October 4, 2024
Jeremiah Fettig
City of Aurora
Planning Department

Re: Third Submission Review – DA 2170-07 – Stafford Logistics Center Commercial – Master Plan Amendment, Infrastructure Site Plan, and Plat.
Application Number: DA-2170-07
Case Numbers: 2024-3001-00; 2019-7001-04; 2024-6002-00

PLANNING DEPARTMENT COMMENTS

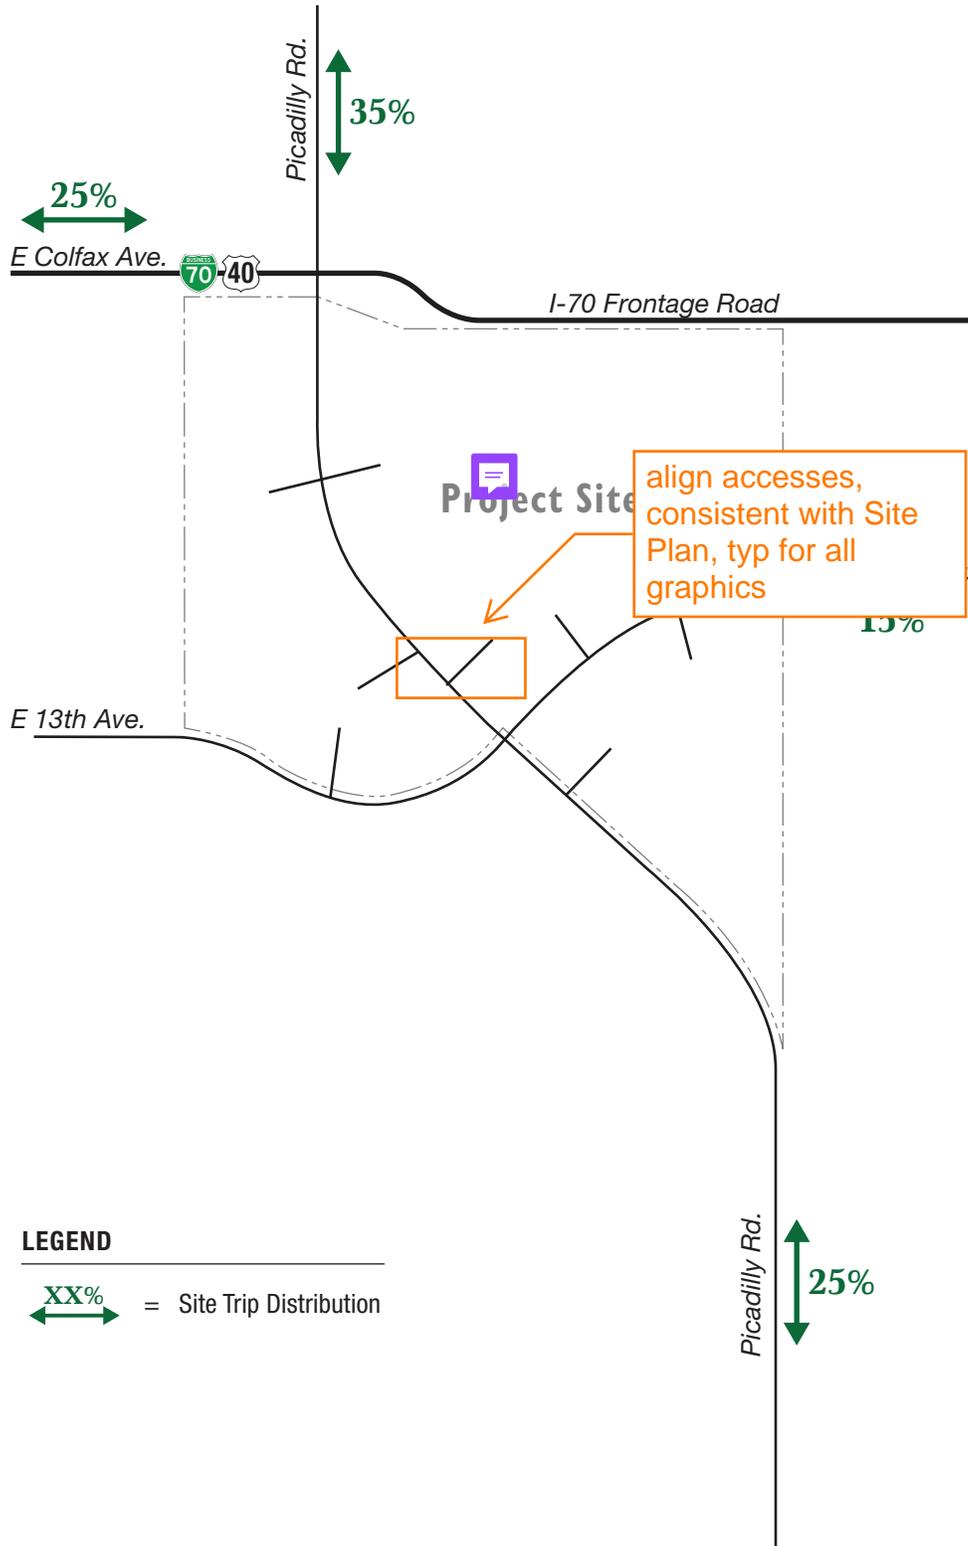
show and evaluate access on Colfax Ave associated with these site traffic volumes

FHU Response: Found and updated misplaced paths in vistro that wrapped around the Amazon site.

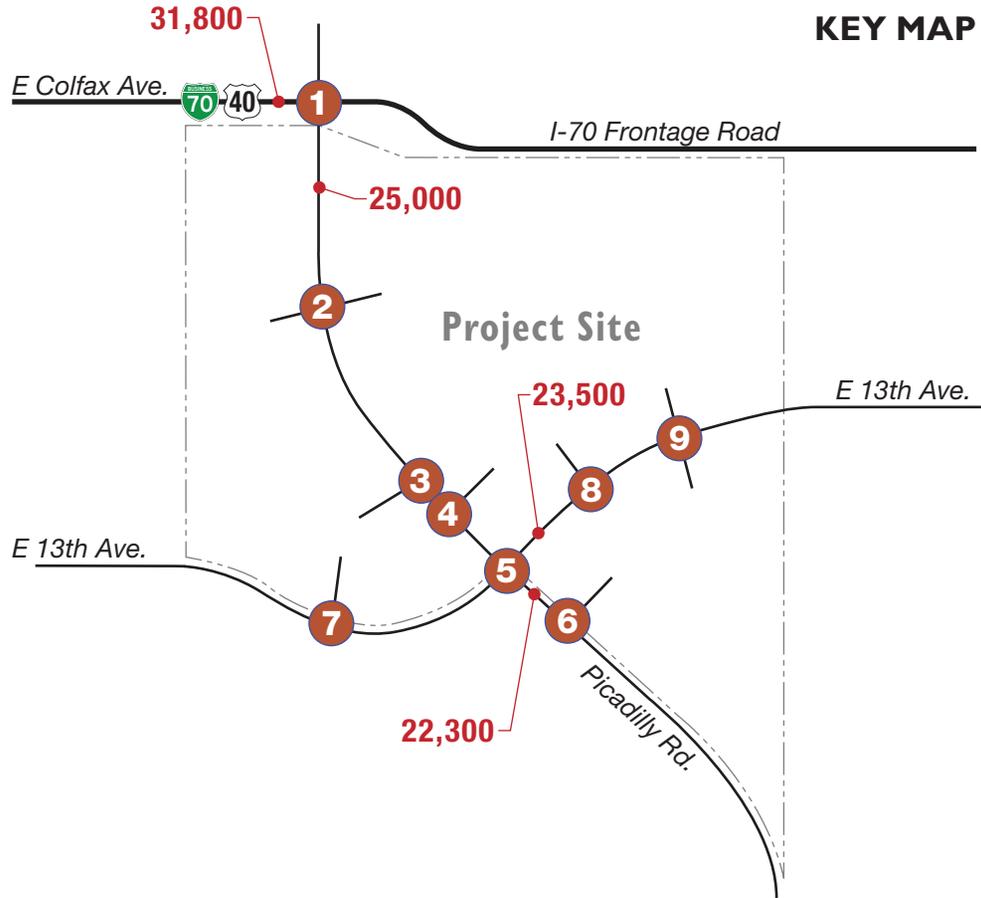
previous comment
add short term background traffic volumes

FHU Response: Added 2030 Time Horizon.

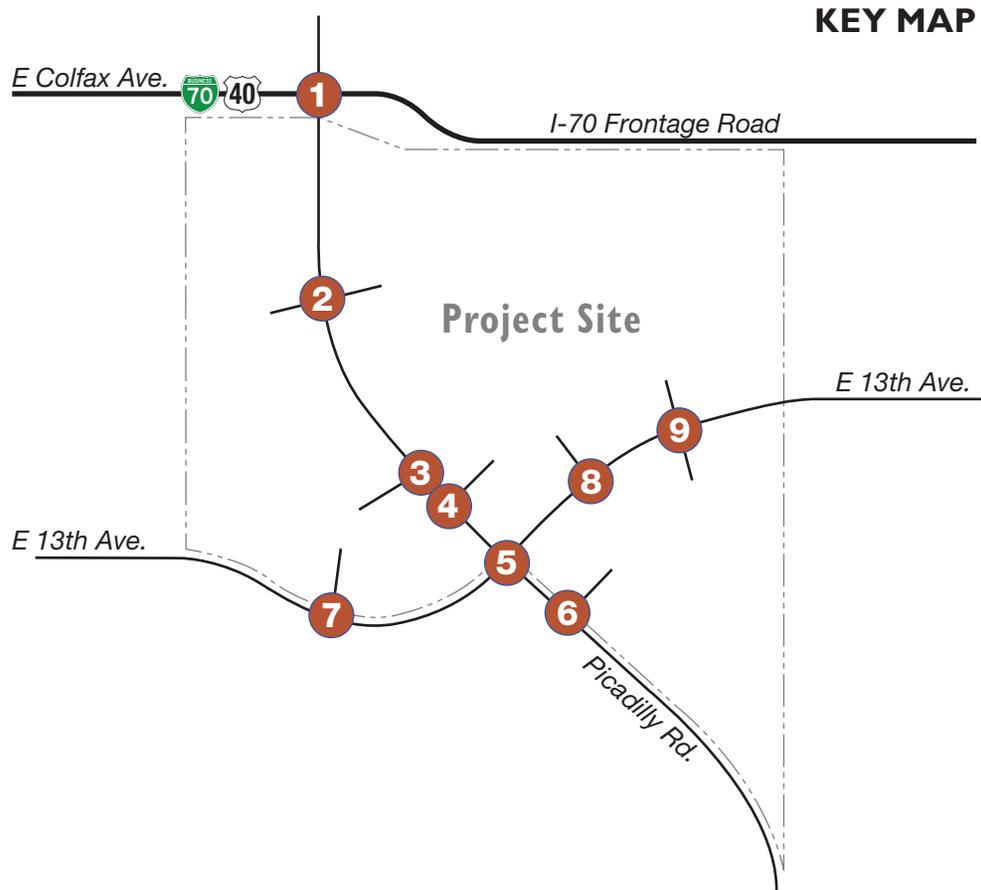
add STOP sign

FHU Response: No stop control at this intersection.

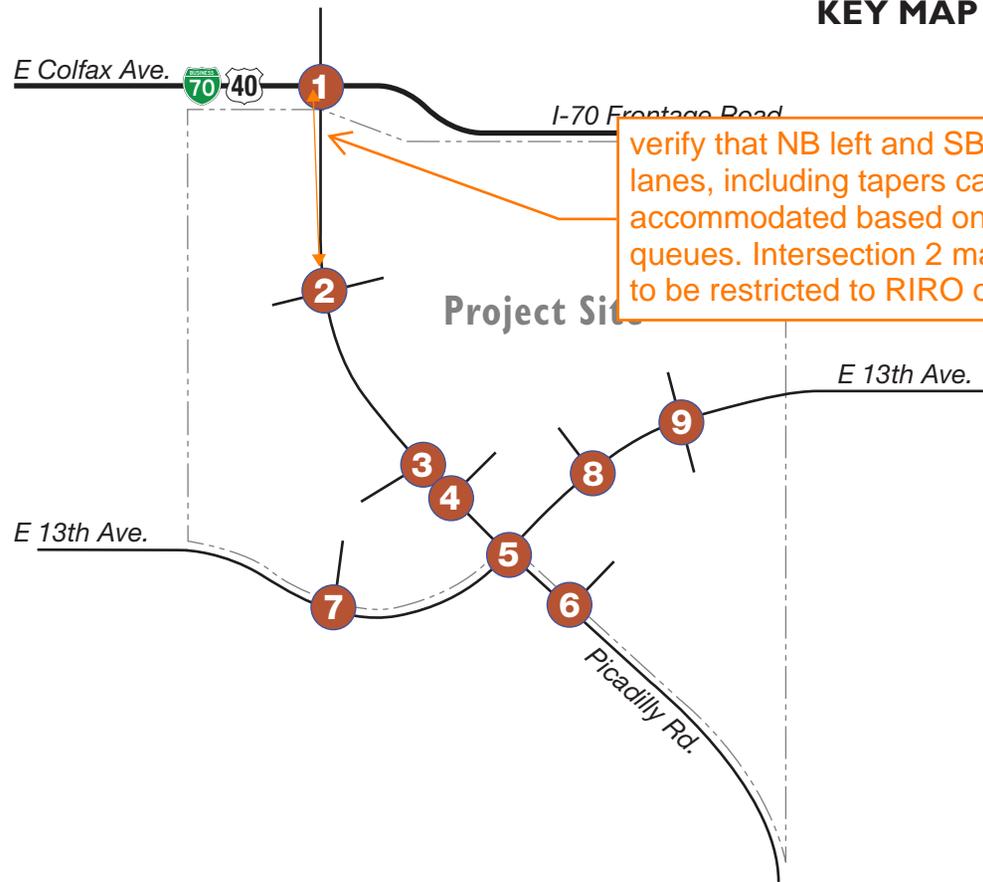
verify that NB left and SB left turn lanes, including tapers can be accommodated based on reported queues. Intersection 2 may need to be restricted to RIRO only

FHU Response: This should fit, 375 ft NBL and 50 ft SBL, about 460 feet of space. This plus taper should fit into the available space.

JOB NO. DCS23-4056	
DATE: 12-05-2023	
SCALE: 1"=60'	
Sheet 3 of 4	
4	07/24/2024 LOT & ESMT UPDATES
3	05/23/2024 LOT & ESMT UPDATES
2	03/15/2024 EASEMENT UPDATES
1	02/16/2024 CITY COMMENTS
NO.	DATE REMARKS
DRAWN BY:	CJD P/A/PM: JCS

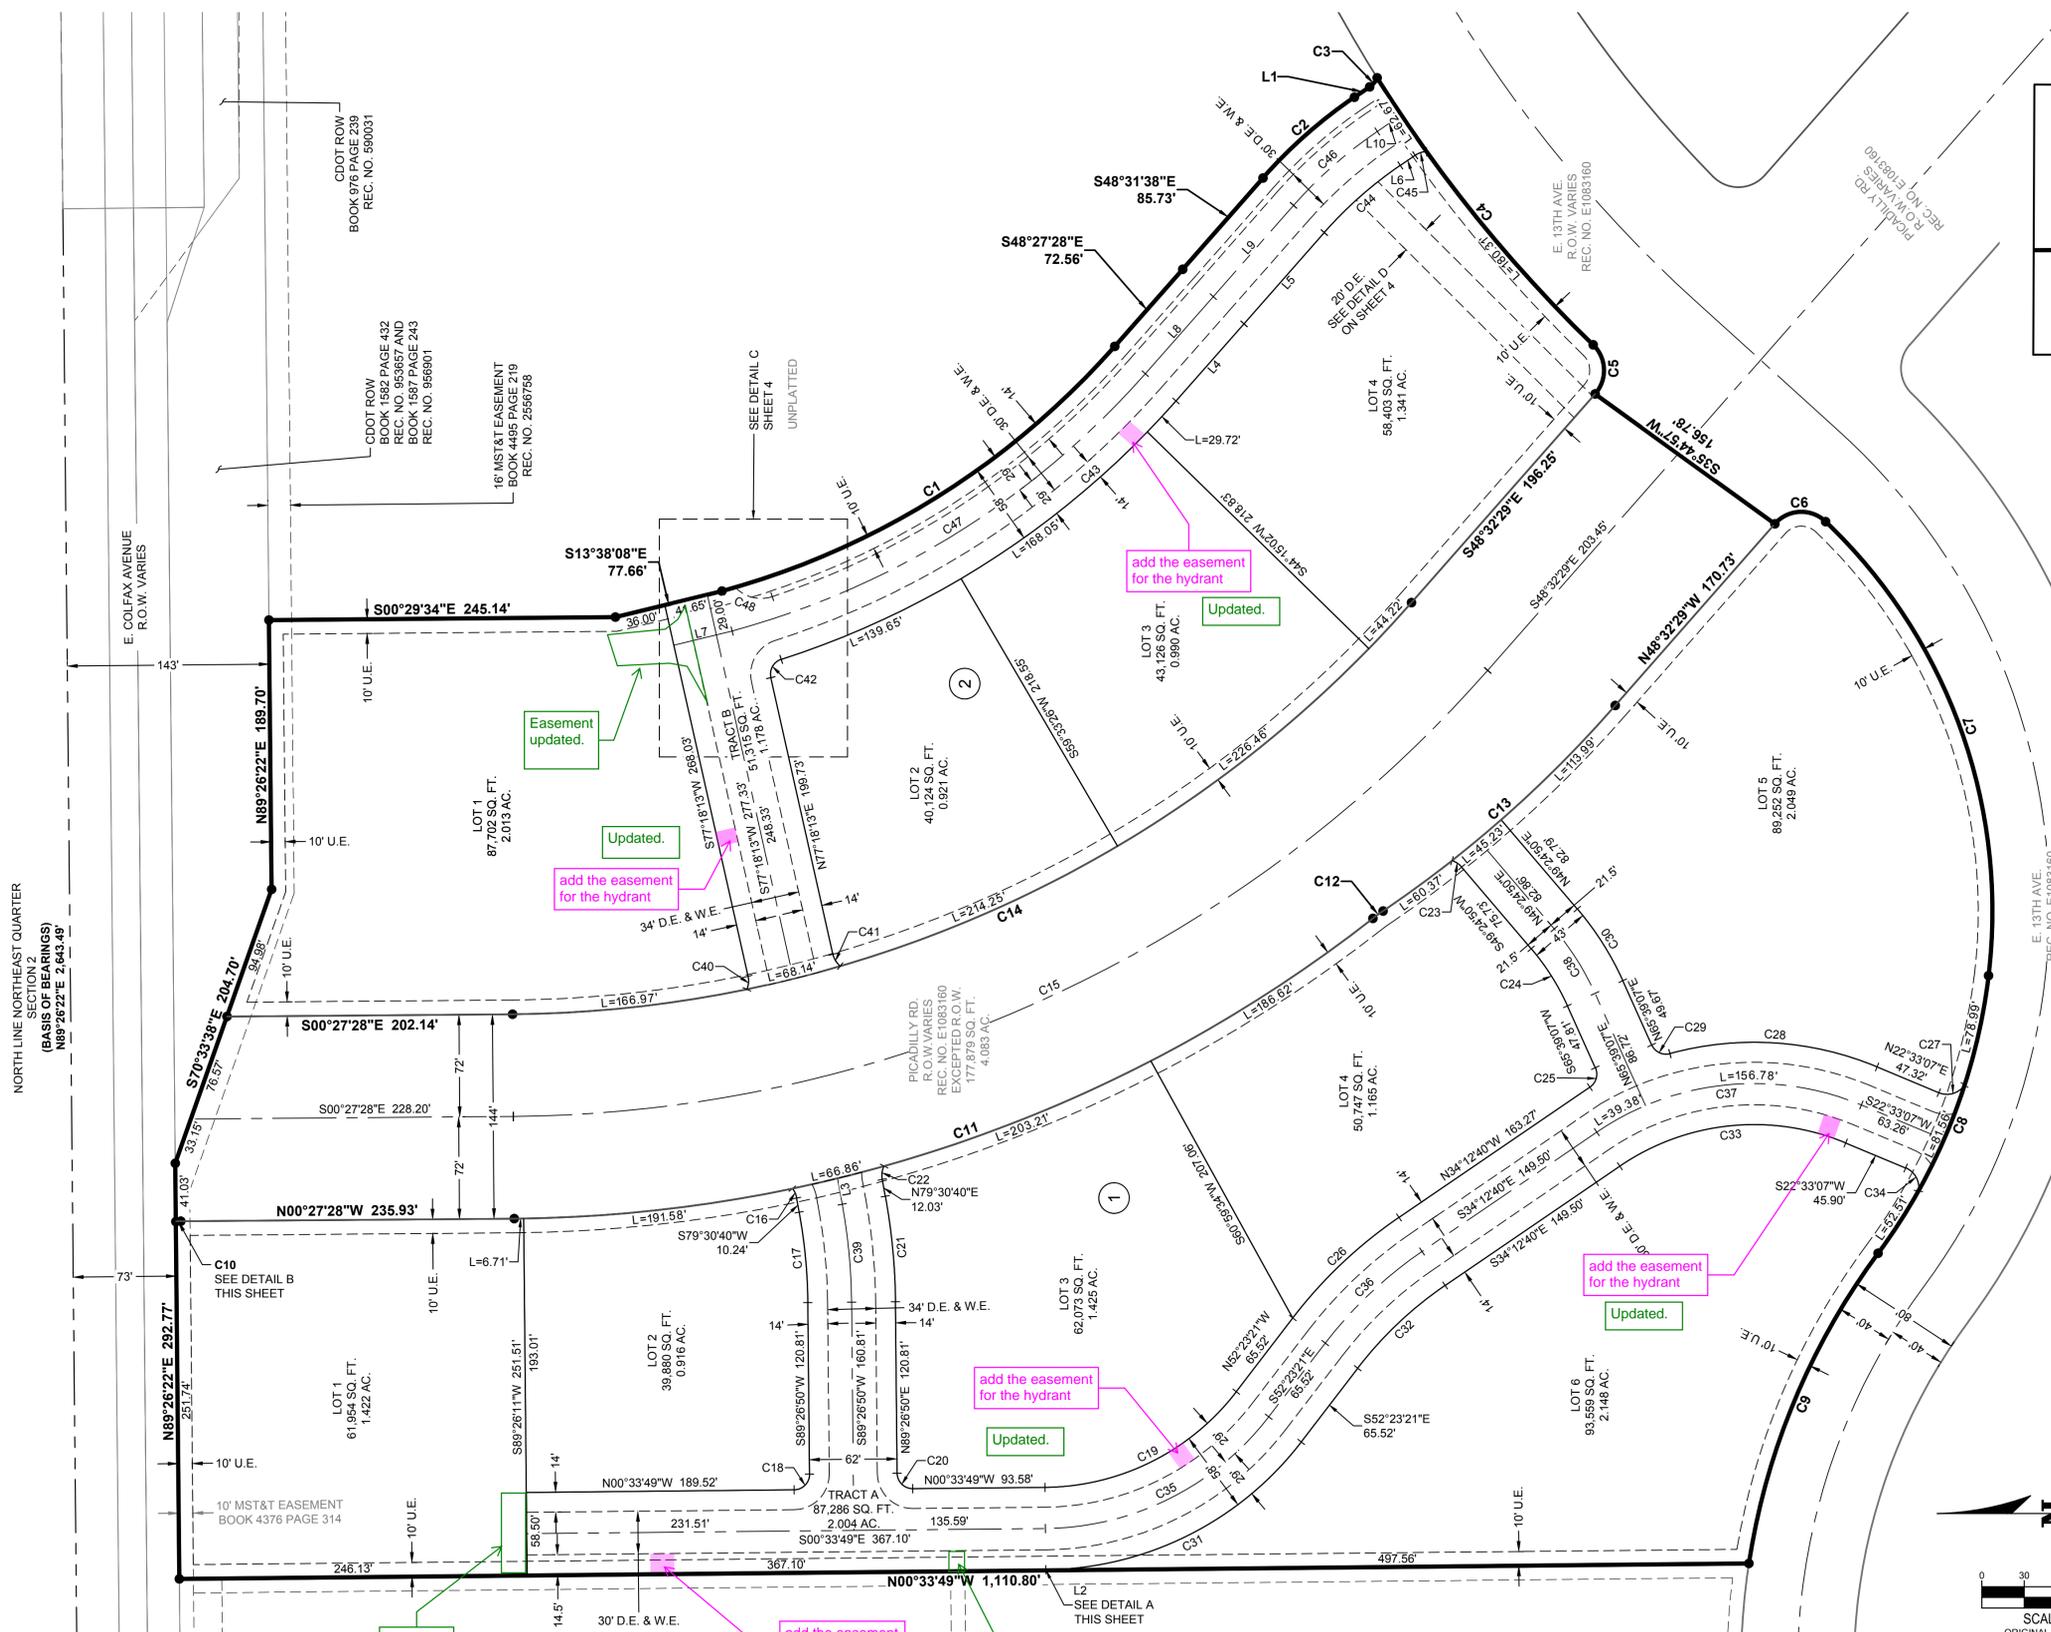
12C. Sheet #3: Add easements for hydrants – all instances. These items have no connection to the WE & DE inside the Tracts and need the connections.

12D. Sheet #3: Add the Bar Scale on the details (Typ.)

WM Response: Easements for hydrants have been added to plat.

WM Response: Scale bars added to details.

JOB NO. DCS23-4056		
DATE: 12-05-2023		
SCALE: 1"=20'		
Sheet 4 of 4		
4	07/24/2024	LOT & ESMT UPDATES
3	05/23/2024	LOT & ESMT UPDATES
2	03/15/2024	EASEMENT UPDATES
1	02/16/2024	CITY COMMENTS
NO.	DATE	REMARKS
DRAWN BY:	CJD	PA/PM: JCS

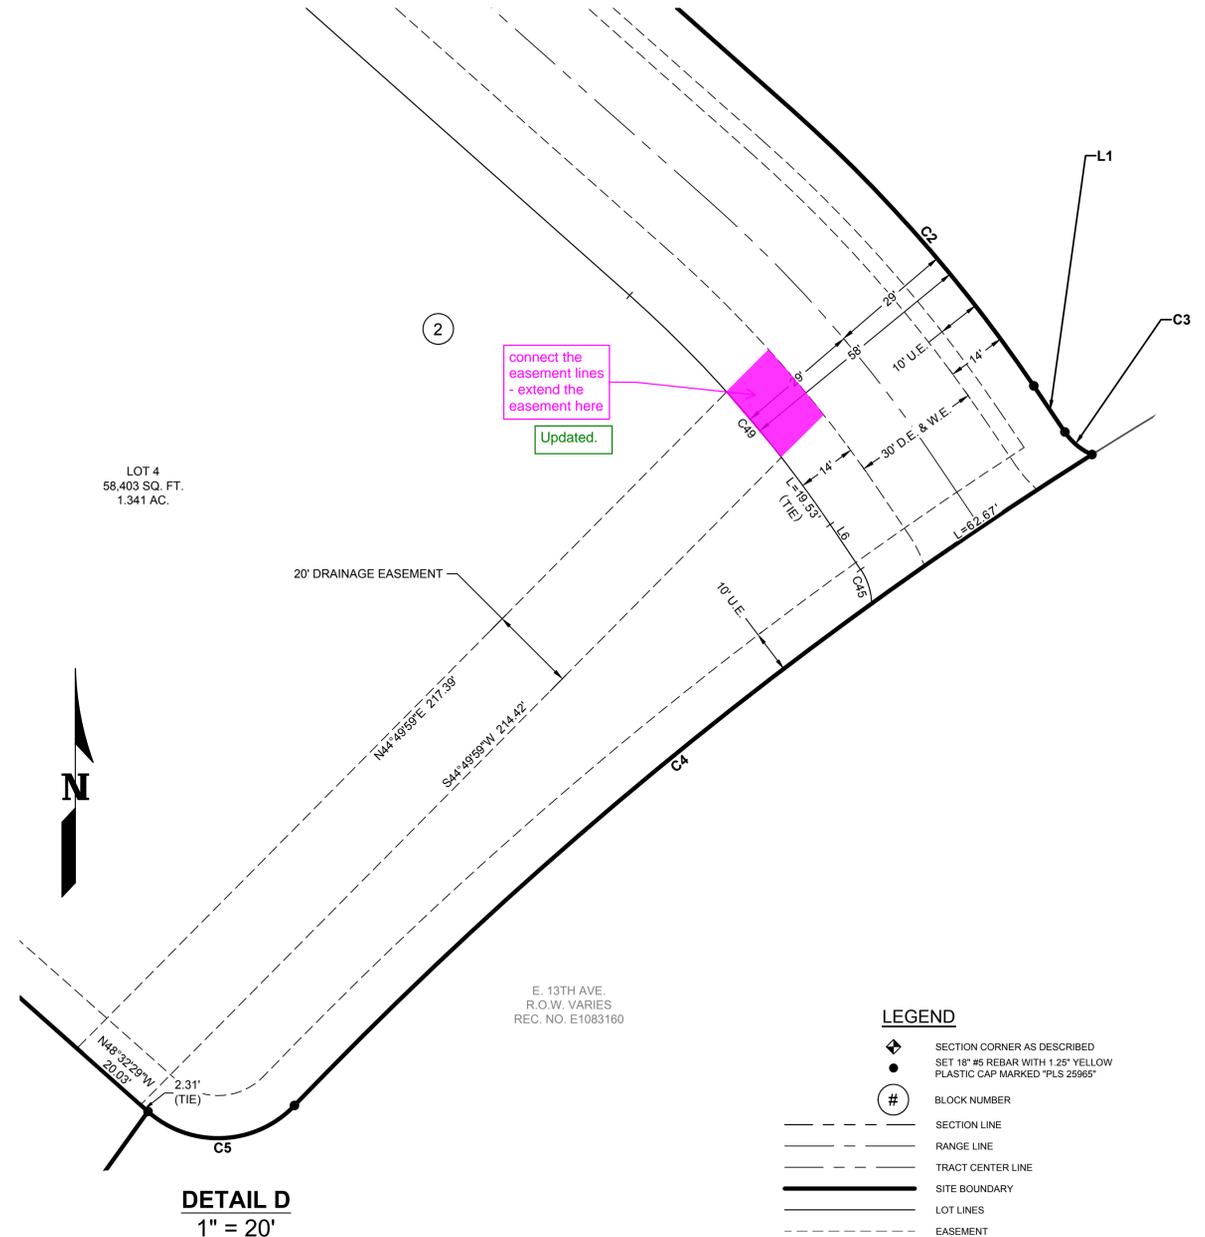
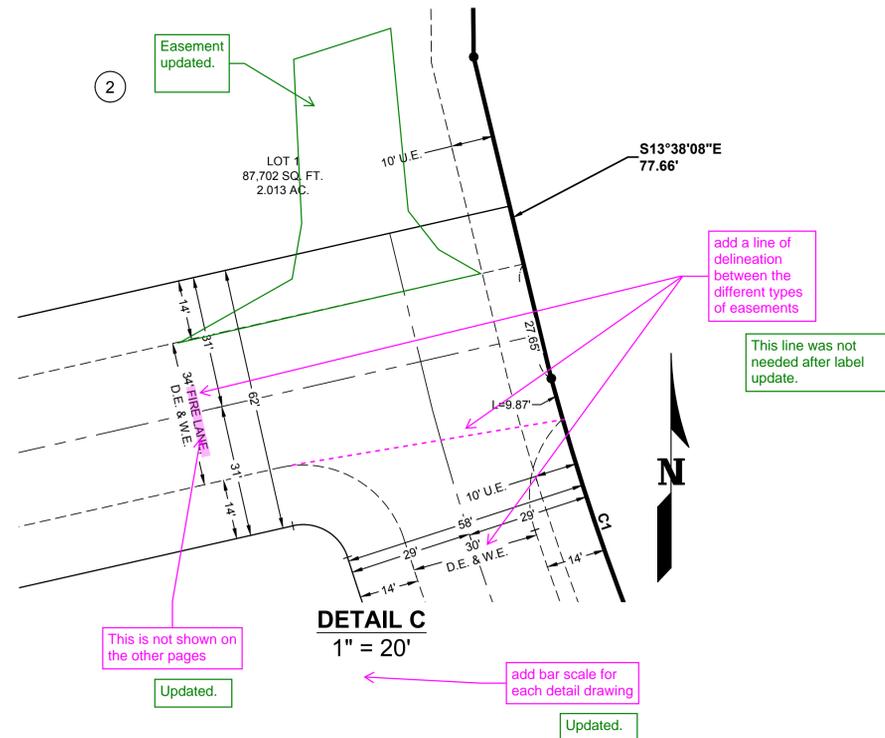
12E. Sheet #4: Detail C is showing two different types of easements. If there are two types of easements, then a line of delineation will be needed at the change of the easements.

12F. Sheet #4: Connect the easement lines - extend the easement here.

12G. Sheet #4: Detail D: connect the Drainage easement to the other Drainage easement in the Tract.

WM Response: Plat updated accordingly.

WM Response: This line was not needed after label update.

WM Response: Plat updated accordingly.

SHEET
TAB 9
Sheet 1 of 1

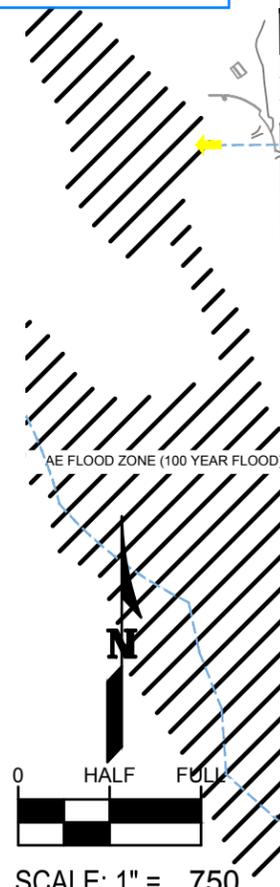
Form J should be included at this point as a residential component has been added to the development. There are two options to reconcile this:

1. Add a Form J to this document filling out all fields that may already be known and putting "TBD" on the rest. If this option is chosen, column A should include PA-13 for trail corridor, parkland, and open space, PA-10 for trail corridor and open space, PA-9 for parkland and open space, PA-3 for trail corridor, and PA-2 for trail corridor.

2. Don't add Form J, but include a note on this sheet stating the following: "MF density will be limited to the ability of PA-13 and PA-9 to meet PROS Parkland Dedication and Open Space Requirements on their respective sites. In addition, it should be noted that the 70' Regional Trail Corridor along Colfax will be credited towards meeting some of the PROS requirement depending on the proposed multifamily density at site planning stage."

WM Response: We have elected to proceed with option 2. Note has been added to TAB 9 accordingly.
